Docket Nos.: STN 50-528, STN 50-529
and STN 50-530

SUBJECT: ISSUANCE OF AMENDMENT NO. 25 TO FACILITY OPERATING LICENSE NO. NPF-41, AMENDMENT NO. 14 TO FACILITY OPERATING LICENSE NO. NPF-51, AND AMENDMENT NO. 3 TO FACILITY OPERATING LICENSE NO. NPF-65, FOR THE PALO VERDE NUCLEAR GENERATING STATION, UNITS 1, 2 AND 3, RESPECTIVELY (TAC NOS. 65939, 65940 AND 65941)

The Amendments revise Section 6 of the Technical Specifications for each of the three Palo Verde Units to incorporate changes reflecting a revised organizational structure for the Palo Verde plant.

FIGURE 6.2-2
 ONSITE ORGANIZATION

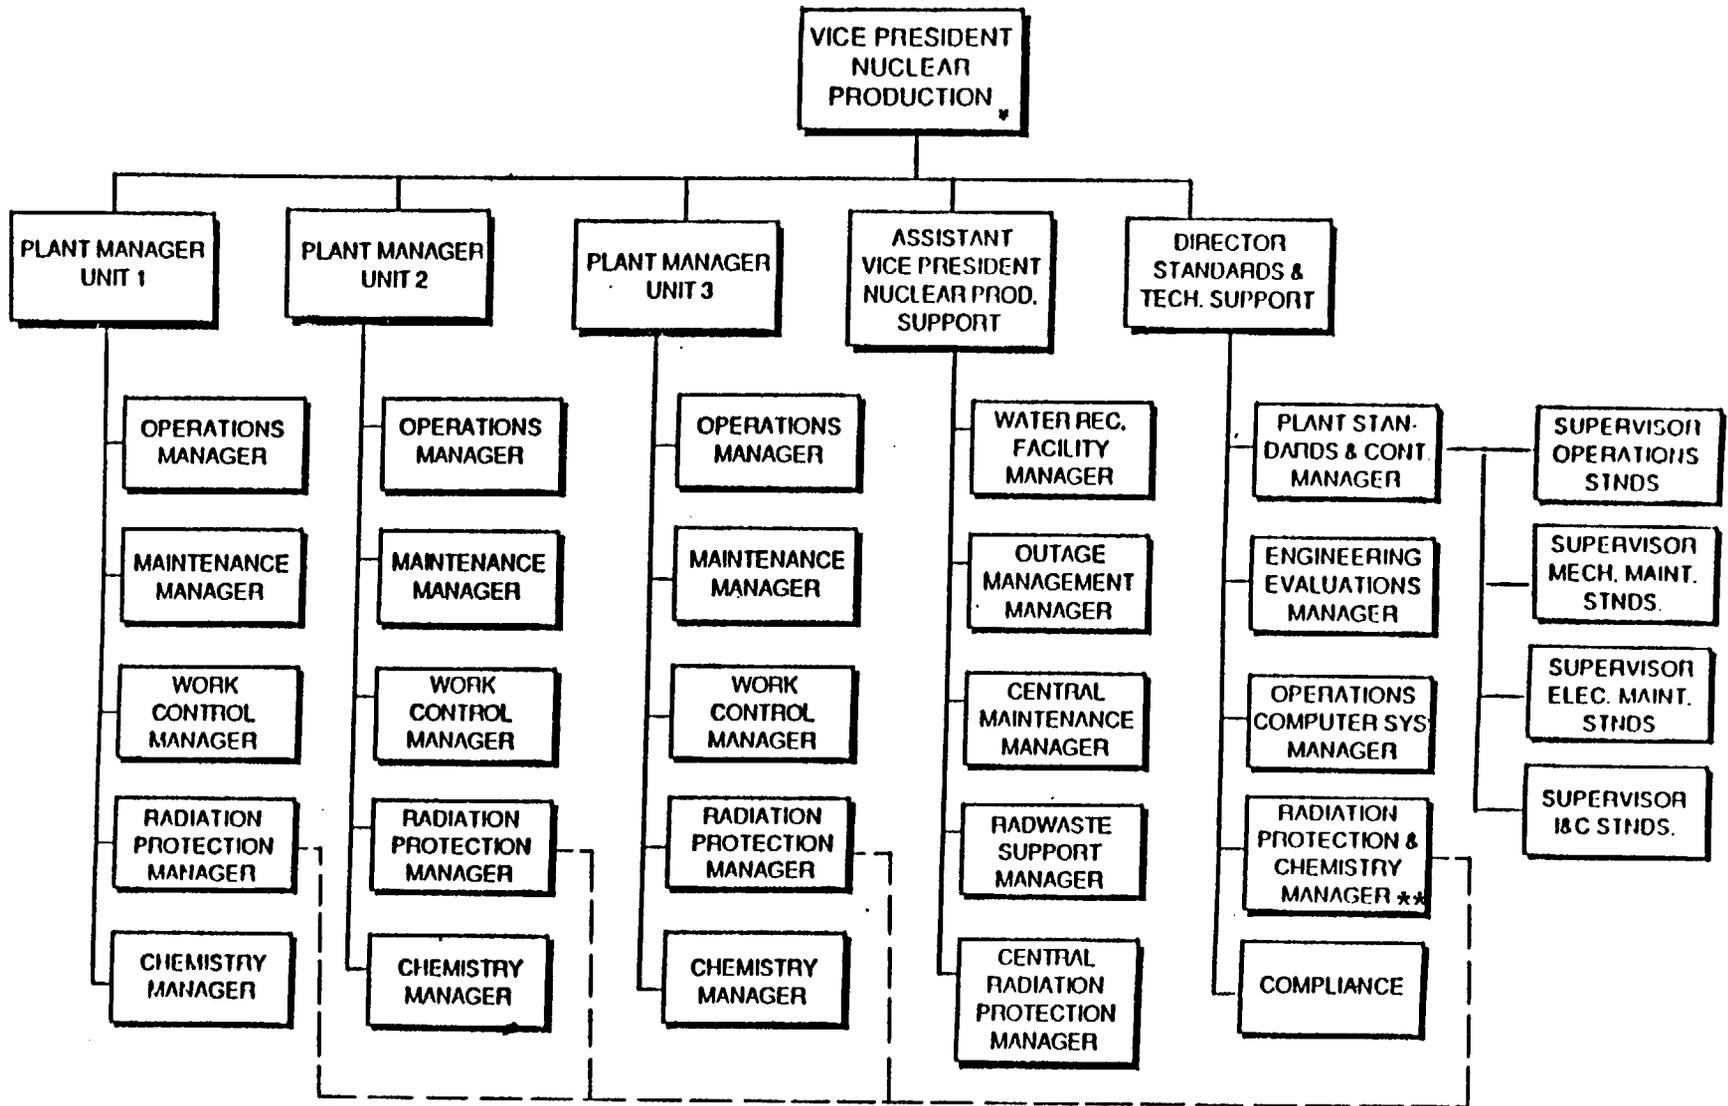
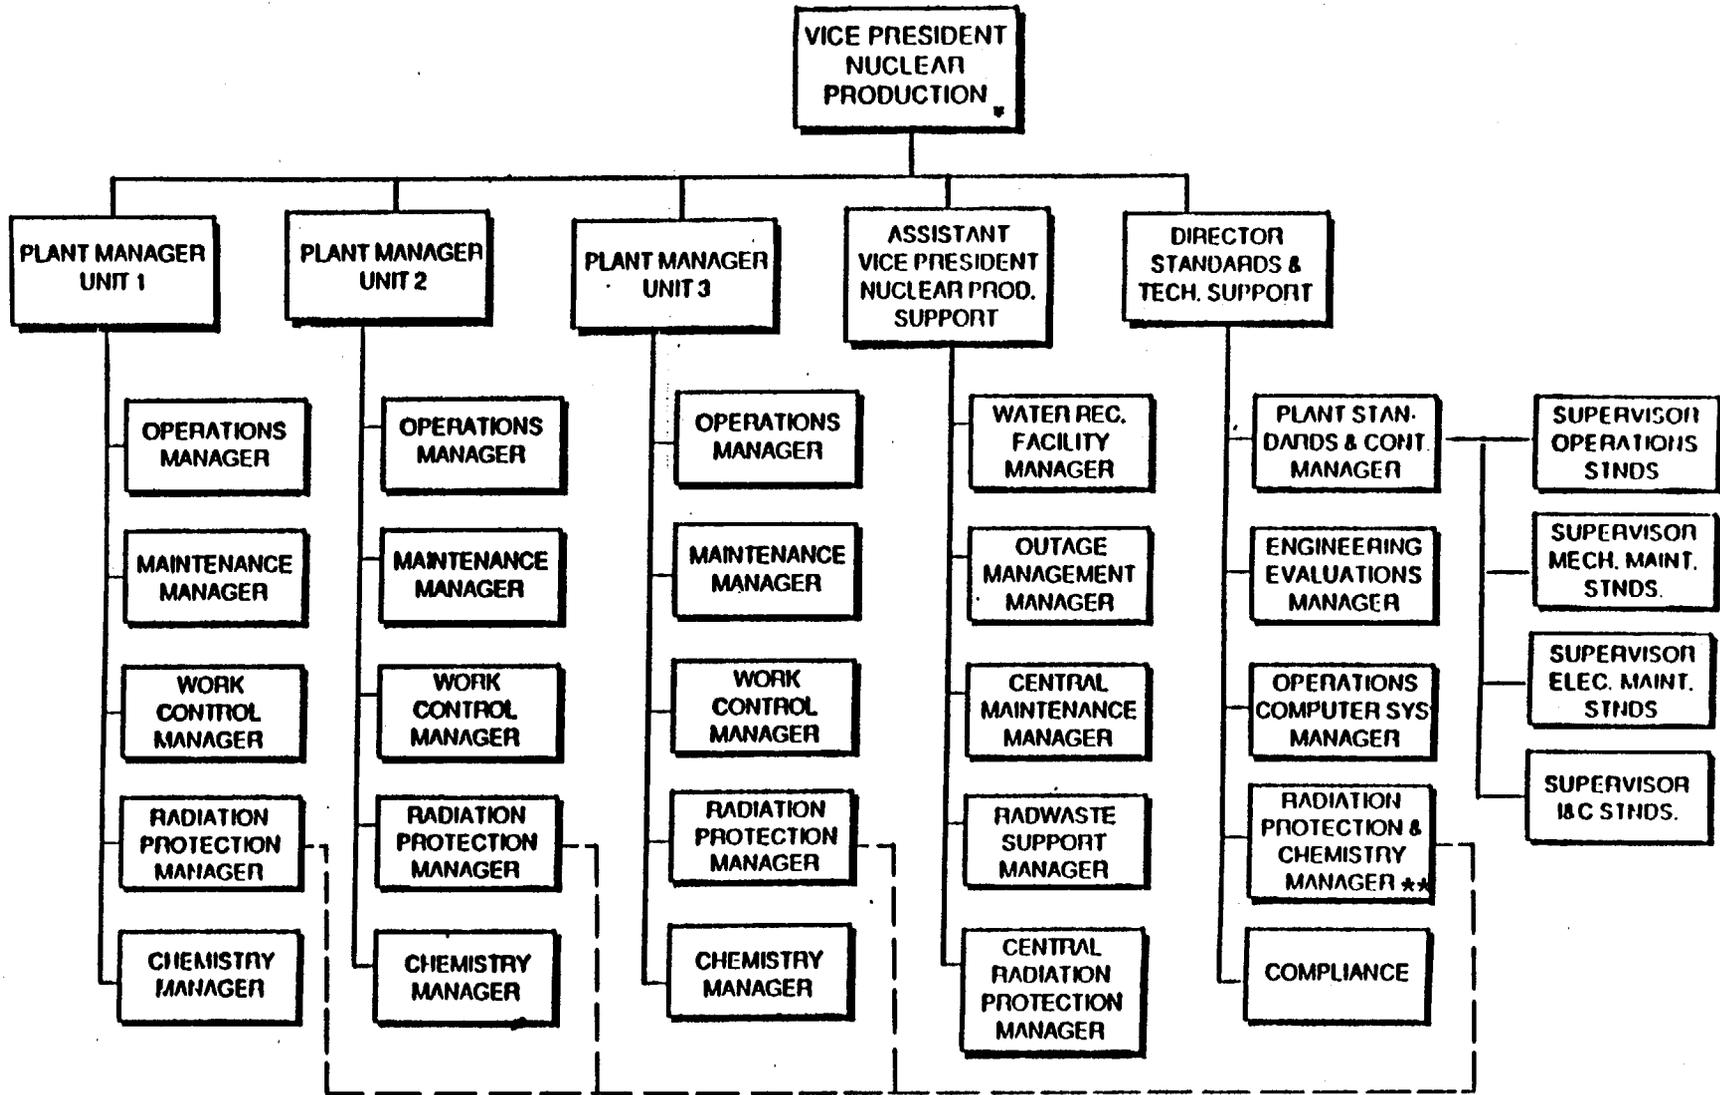
6.2.2.1 The unit organization shall be as shown in Figure 6.2-2 and:

FIGURE 6.2-1

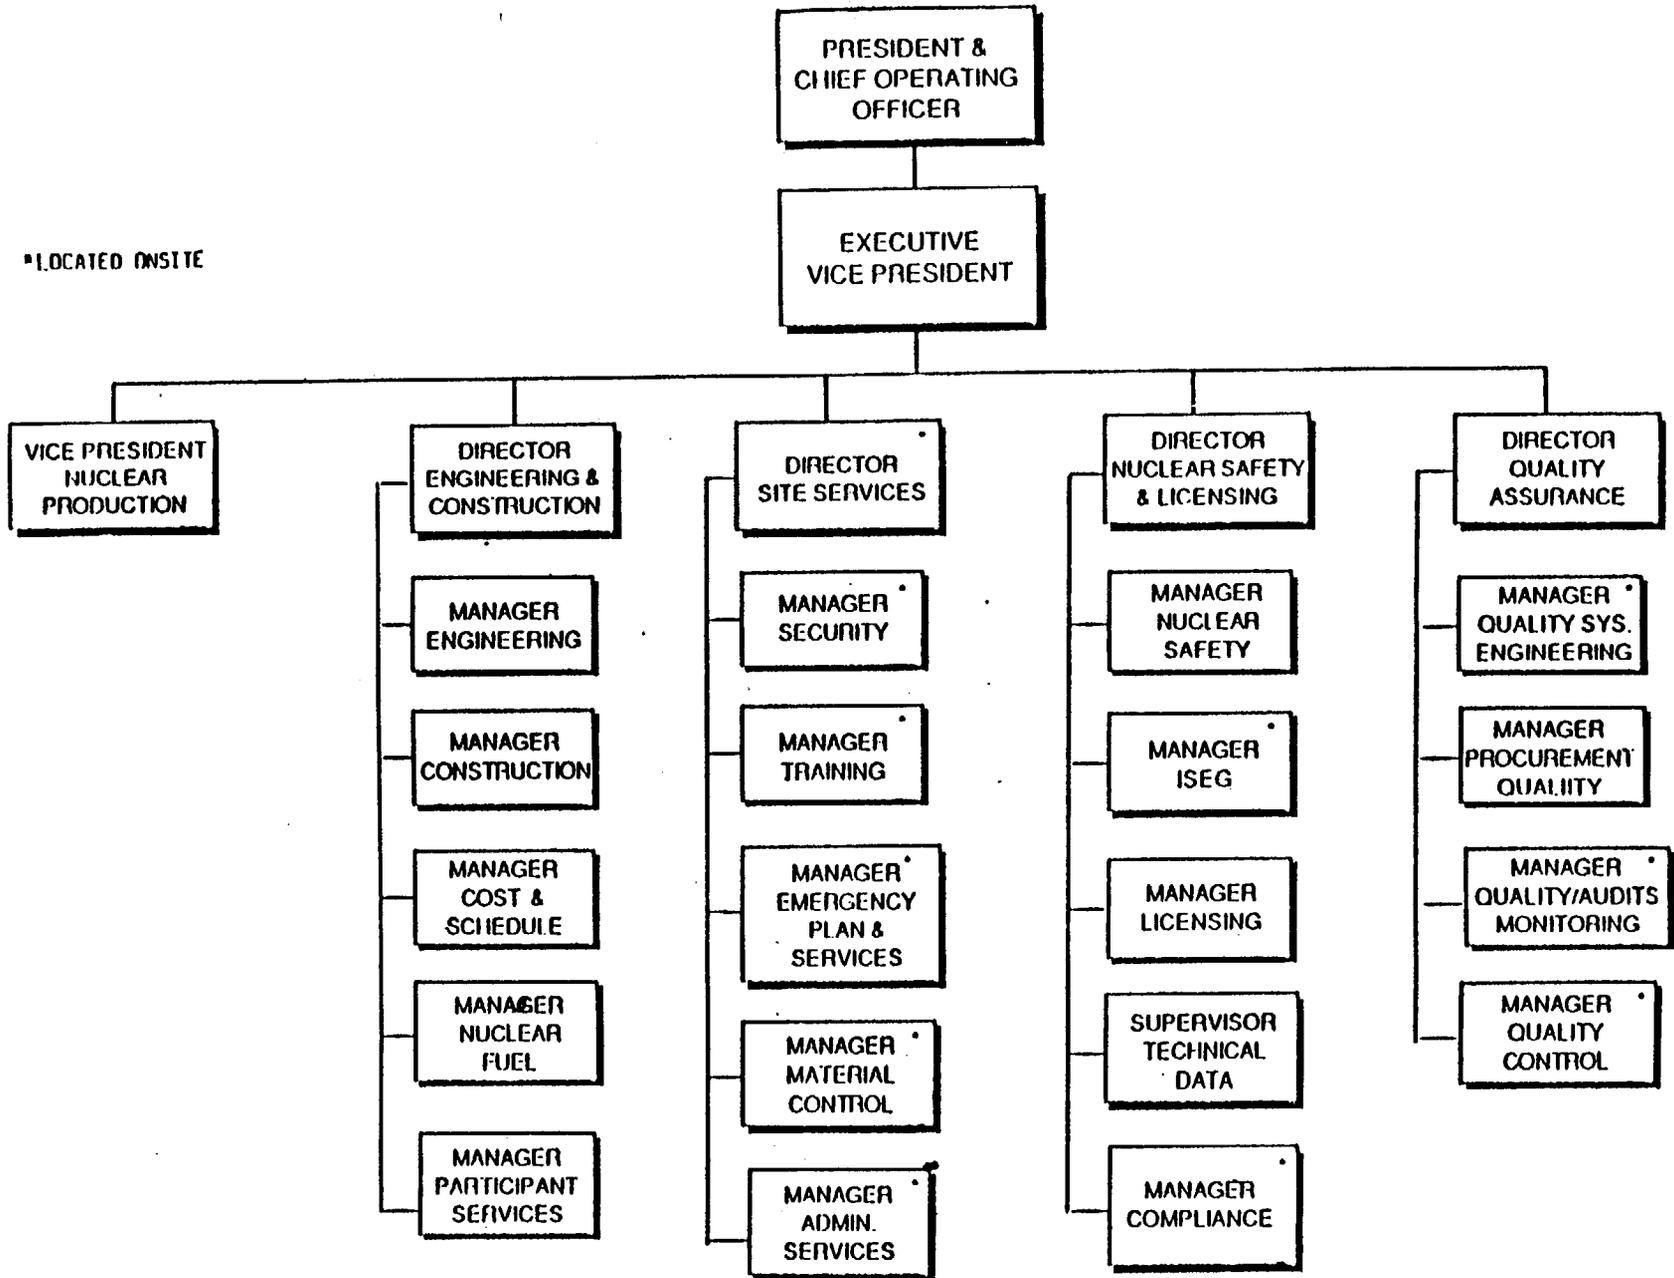
6.2.1 The offsite organization for unit management and technical support shall be as shown in Figure 6.2-1.

FIGURE 6.2-2

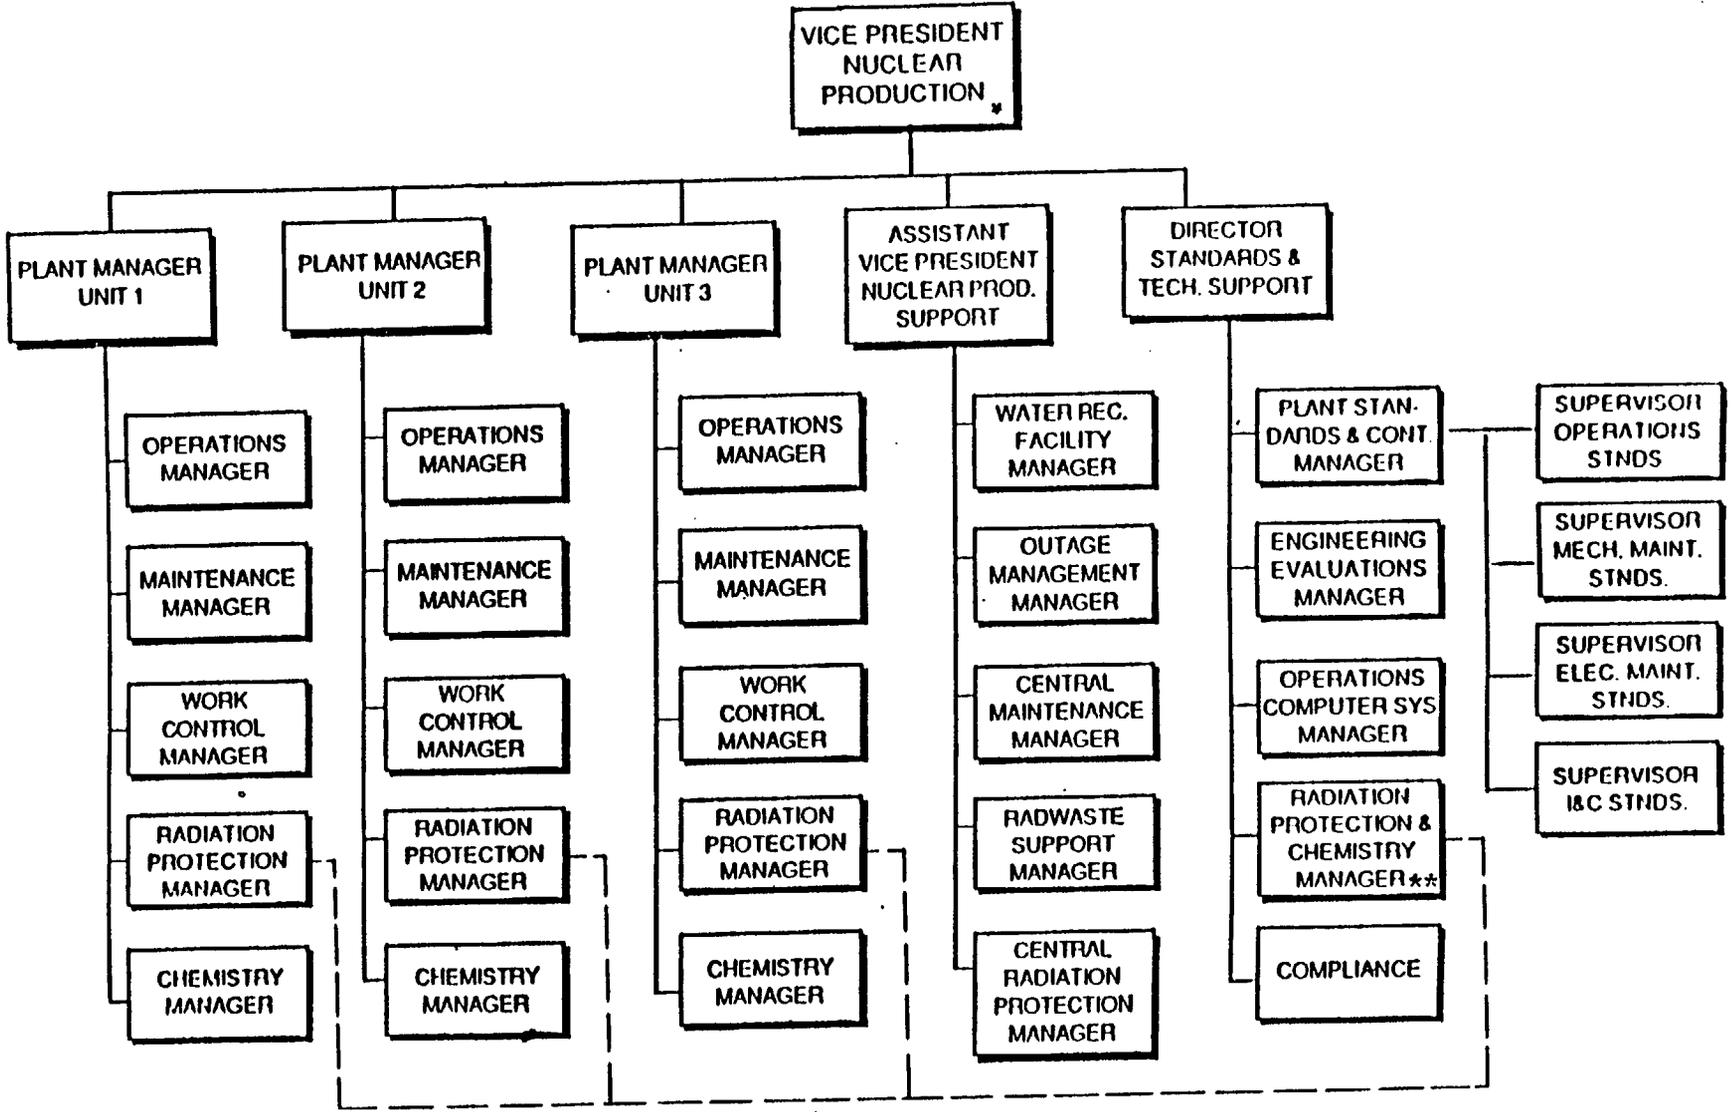
6.2.2.1 The unit organization shall be as shown in Figure 6.2-2 and:
